ADDENDUM ONE

Project: **Sullivan County Indian Springs Elementary School HVAC Replacement**

April 5, 2023

This Addendum is part of the Contract Documents for the above referenced project and modifies the original drawings and/or specifications, dated **3/20/23**, as noted below. The bidder shall acknowledge receipt of this Addendum in the place provided in the Bid Form. The published bid date and time shall remain the same.

A-11

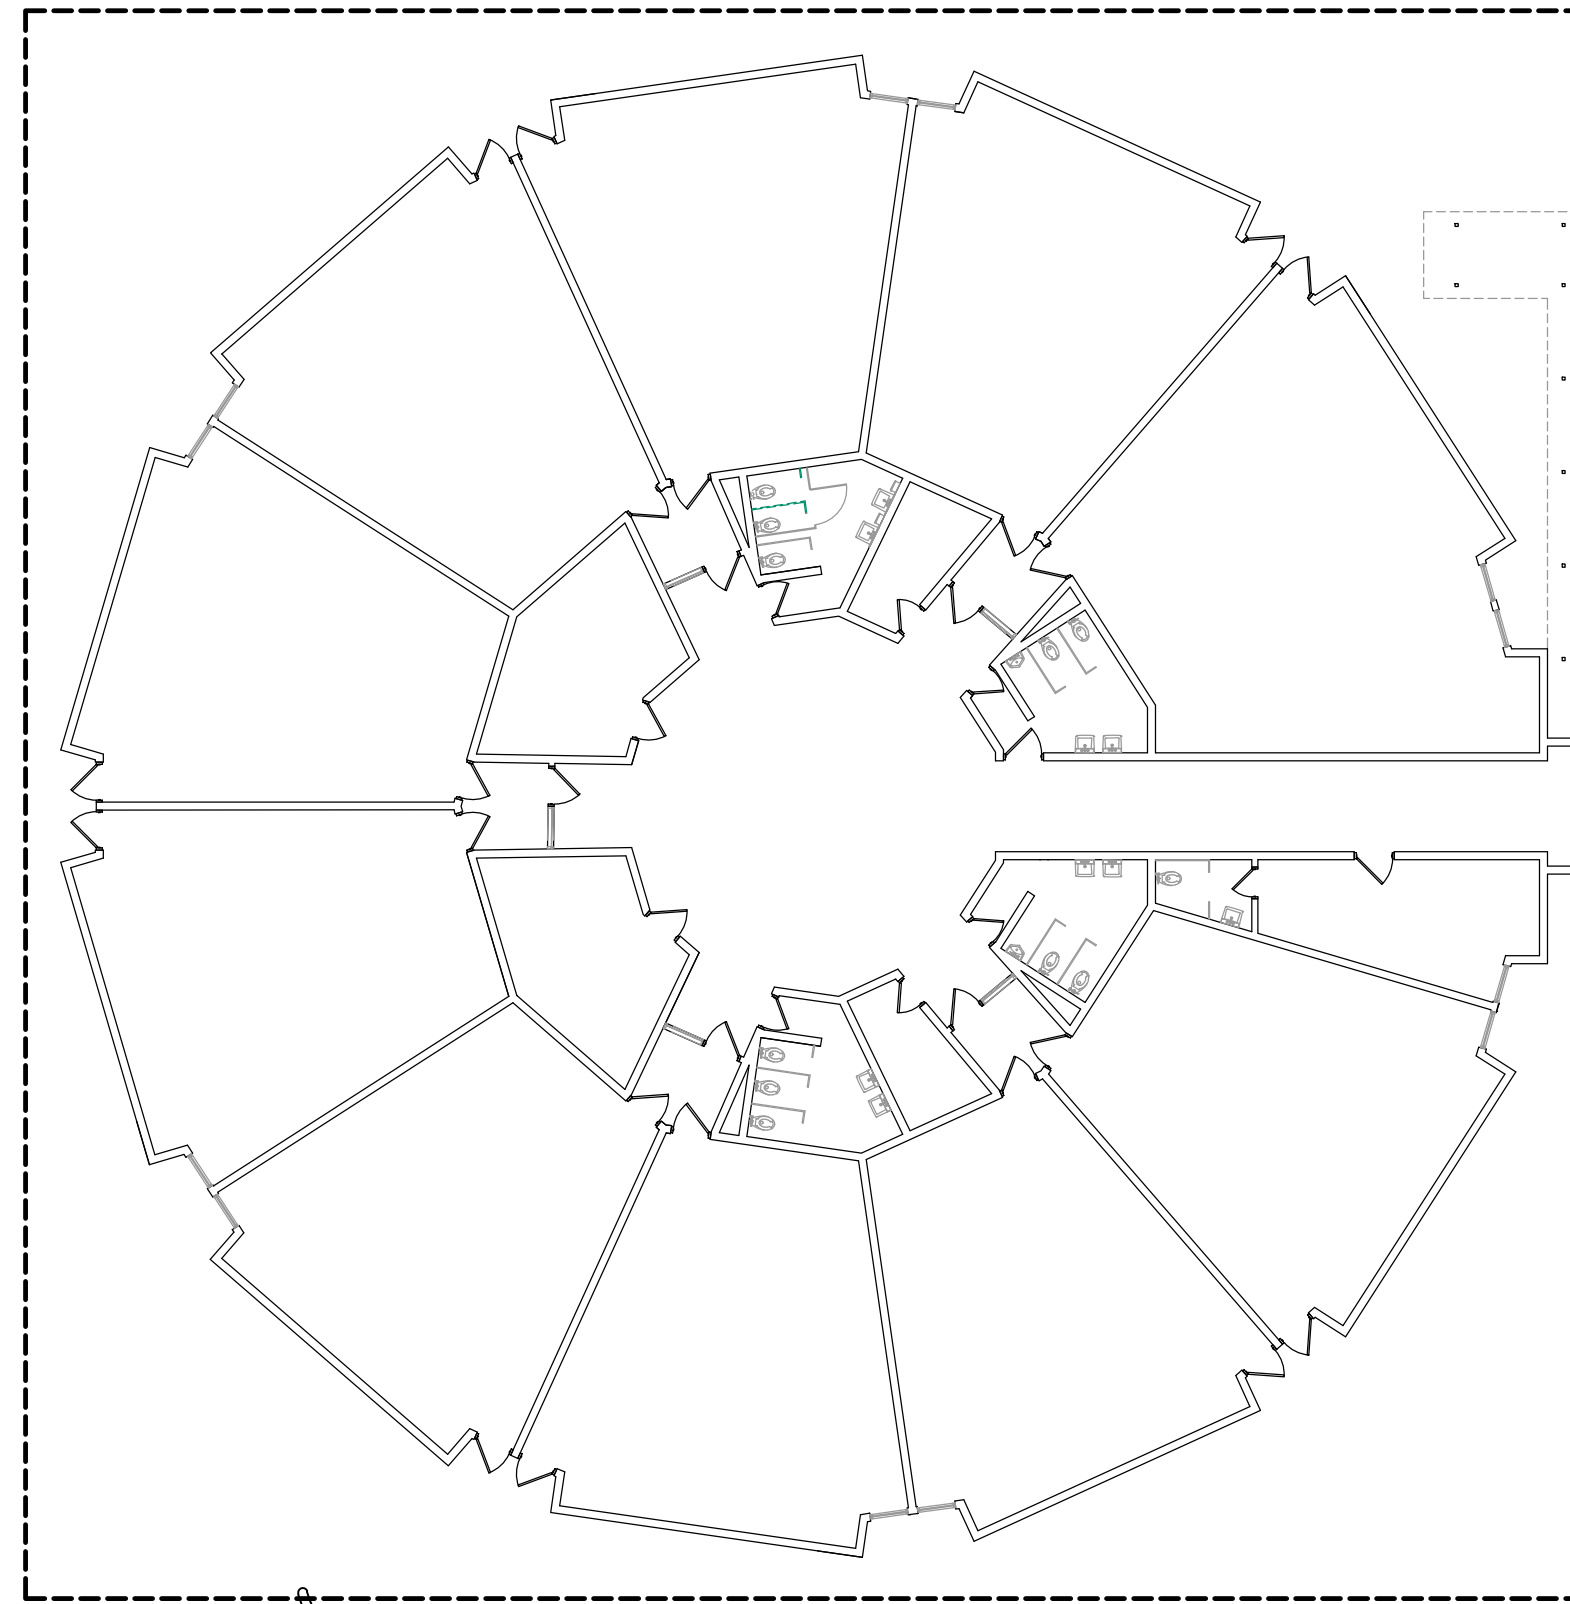
1. **Lintel Schedule.** See attached Lintel Schedule for use with any new or enlarged wall openings.
2. **Drawing G-00** – See revised drawing to include additional electrical plans.
3. **Drawing A-11** – See drawing for chain link fence and gates to surround exterior HVAC units.
4. **Drawing E-01** – See revised drawing.
5. **Drawing E-11A** - See additional drawing.
6. **Drawing E-11B** – See additional drawing.
7. **Drawing E-52** – See revised drawing.

- SEE PIPING CHASE TYPES ON DRAWING A-10 FOR DIMENSIONS OF CHASES NOTED ON PLANS. ALL CHASES TO EXTEND FLOOR TO CEILING.
- NEW 6'-0" HIGH CHAIN LINK FENCE, POSTS AND GATES.

E-01

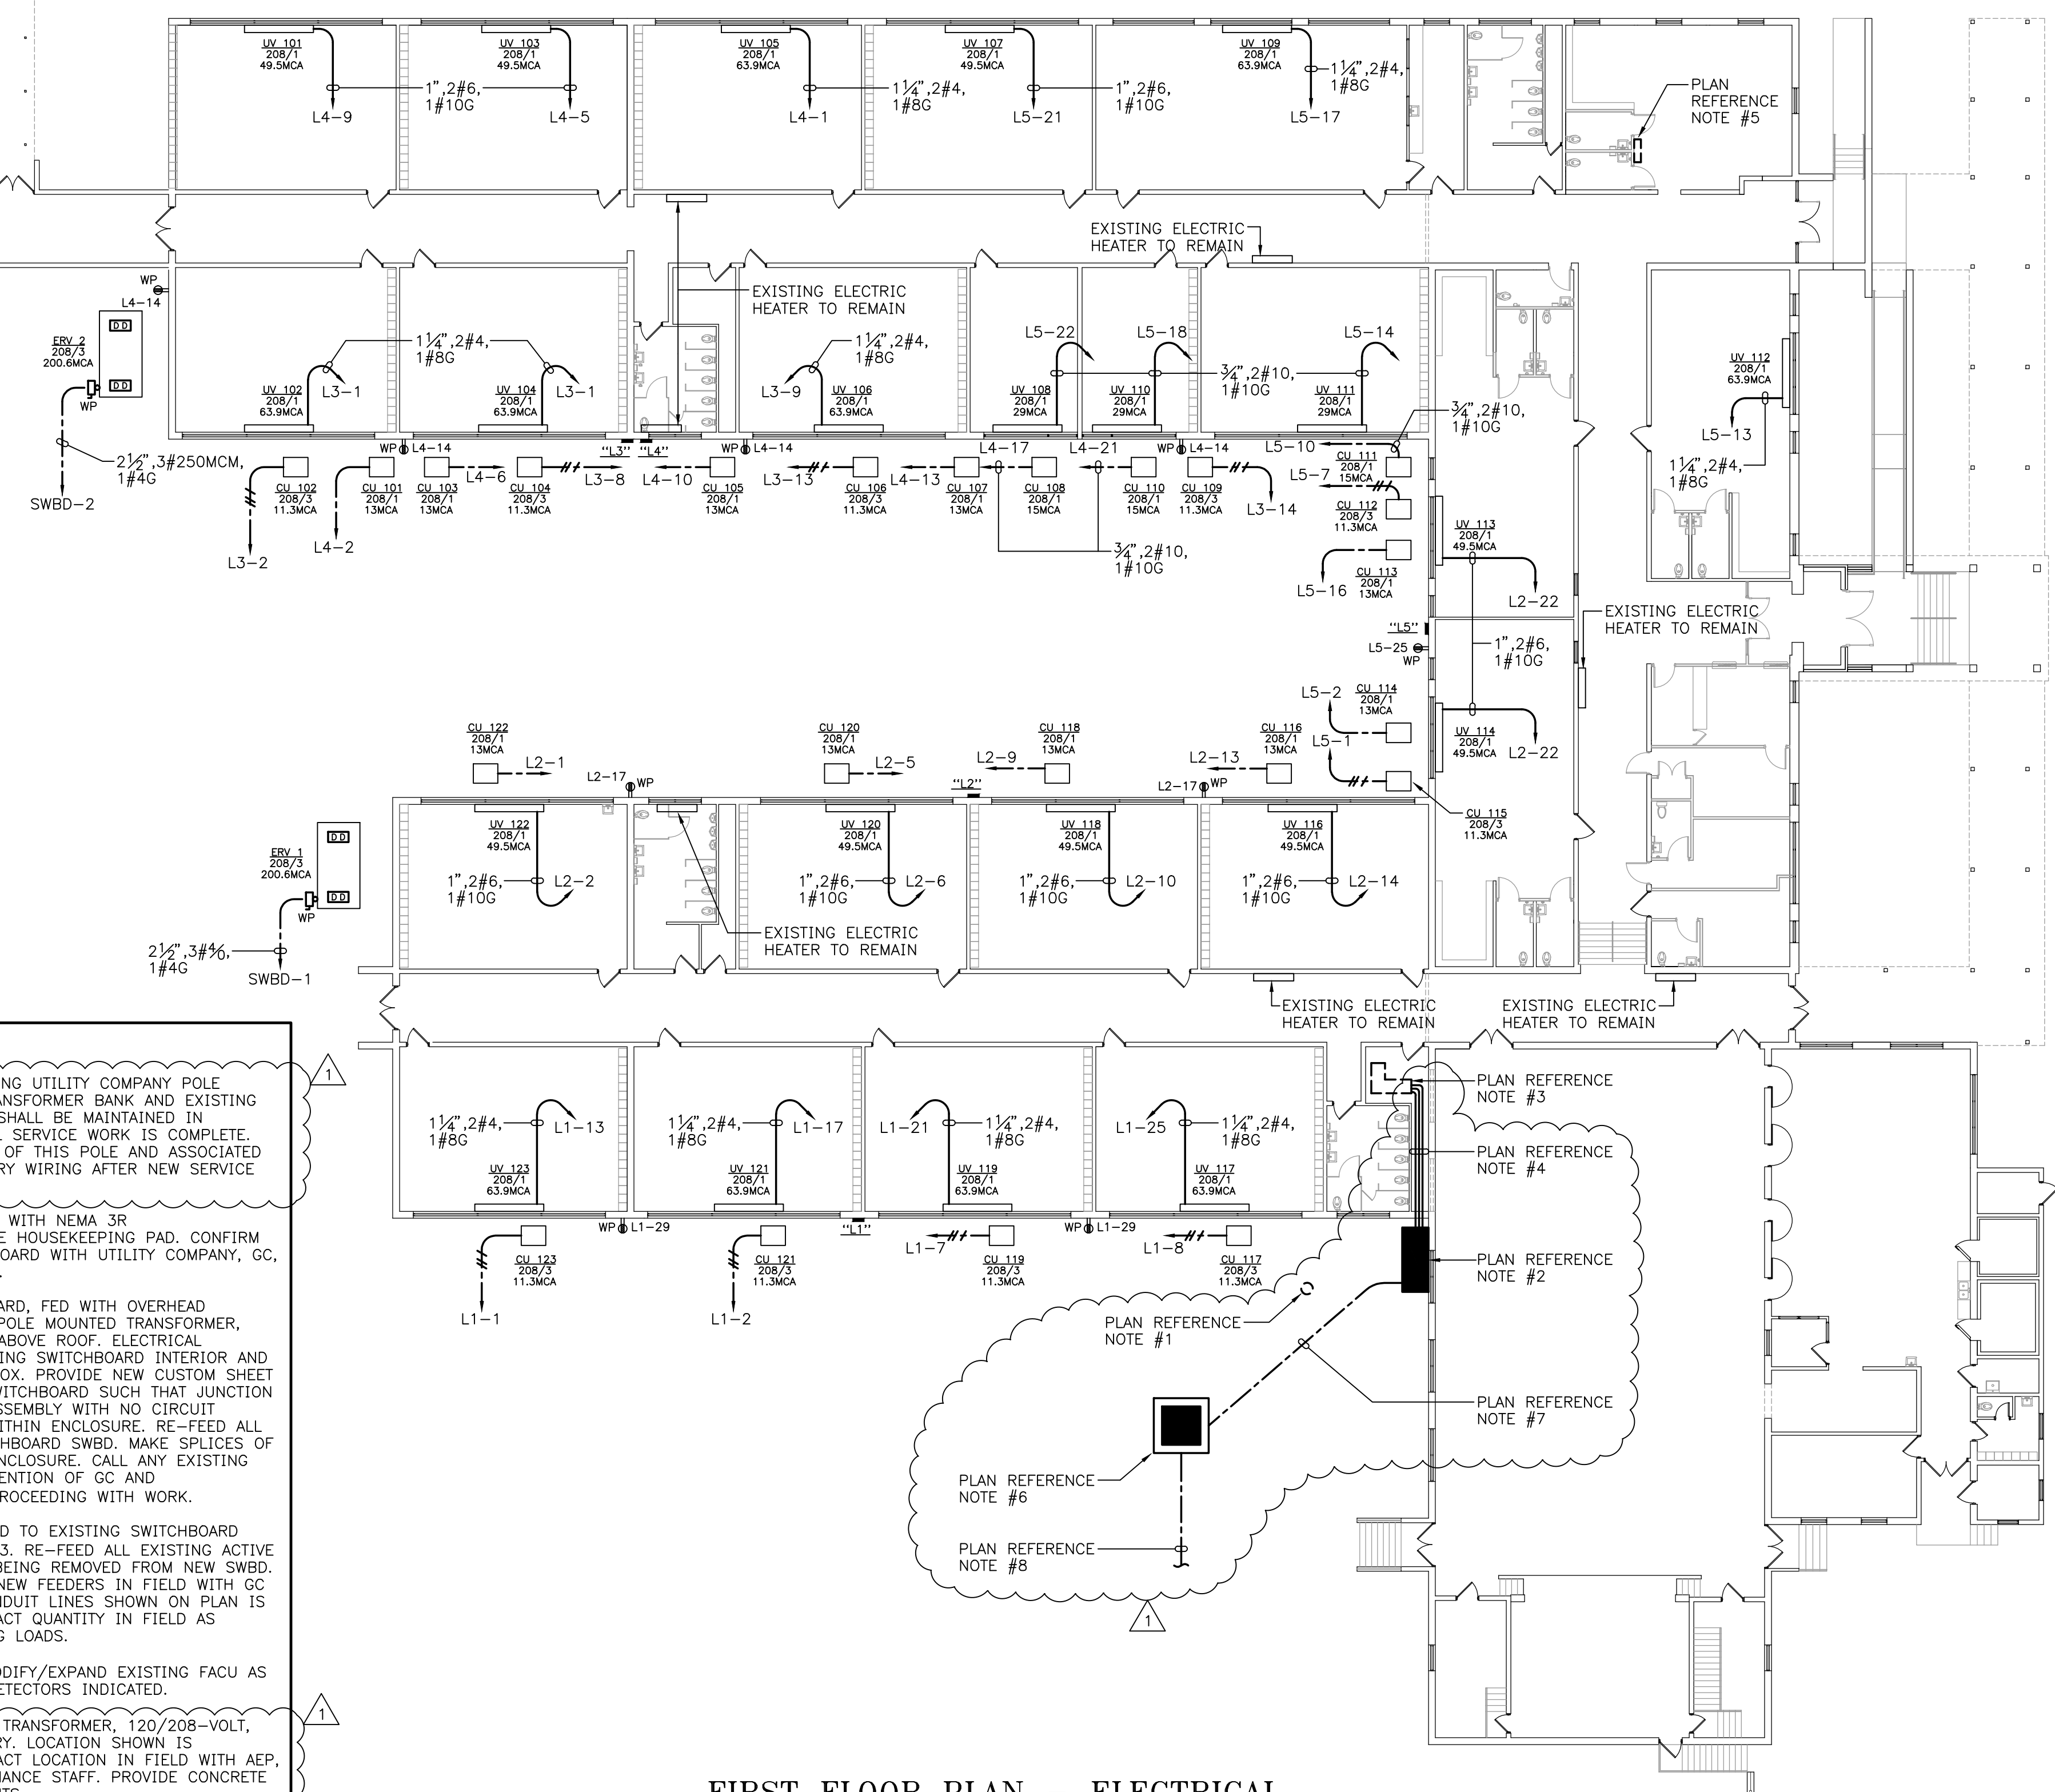
no.	date	rev. description
1	4-3-23	ELECTRICAL SERVICE REVISION

- PROVIDE NEW SWITCHBOARD SWBD WITH NEMA 3R ENCLOSURE. PROVIDE 6" CONCRETE HOUSEKEEPING PAD. CONFIRM EXACT LOCATION OF NEW SWITCHBOARD WITH UTILITY COMPANY, GC, AND OWNER'S MAINTENANCE STAFF.

- EXISTING FACU FOR BUILDING. MODIFY/EXPAND EXISTING FACU AS REQUIRED TO SERVE NEW DUCT DETECTORS INDICATED.
 - PROPOSED NEW AEP PADMOUNTED TRANSFORMER, 120/208-VOLT, 3-PHASE, 4-WIRE, WYE SECONDARY. LOCATION SHOWN IS DIAGRAMMATIC ONLY. CONFIRM EXACT LOCATION IN FIELD WITH AEP, ARCHITECT, AND OWNER'S MAINTENANCE STAFF. PROVIDE CONCRETE PAD PER UTILITY CO. REQUIREMENTS.

- PROVIDE UNDERGROUND SECONDARY WIRING FROM AEP PADMOUNTED TRANSFORMER TO NEW SWITCHBOARD "SWBD". SEE FEEDER DIAGRAM ON DRAWING E-52 FOR ADDITIONAL INFORMATION. LINE LOCATION SHOWN IS DIAGRAMMATIC ONLY. CONFIRM EXACT ROUTING OF UNDERGROUND LINE IN FIELD. LOCATE LINE MINIMUM 24" BELOW FINISHED GRADE.

- PROVIDE 4-3" EMPTY CONDUITS TO NEW AEP PADMOUNTED TRANSFORMER FROM NEW AEP RISER POLE TO BE INSTALLED ALONG ODD FELLOW ROAD. FOR PURPOSES OF BIDDING, ASSUME A LINEAR DISTANCE OF APPROXIMATELY 80 FEET FOR THIS UNDERGROUND PRIMARY POWER LINE. CONFIRM EXACT ROUTING OF UNDERGROUND LINE IN FIELD. LOCATE LINE MINIMUM 48" BELOW FINISHED GRADE.
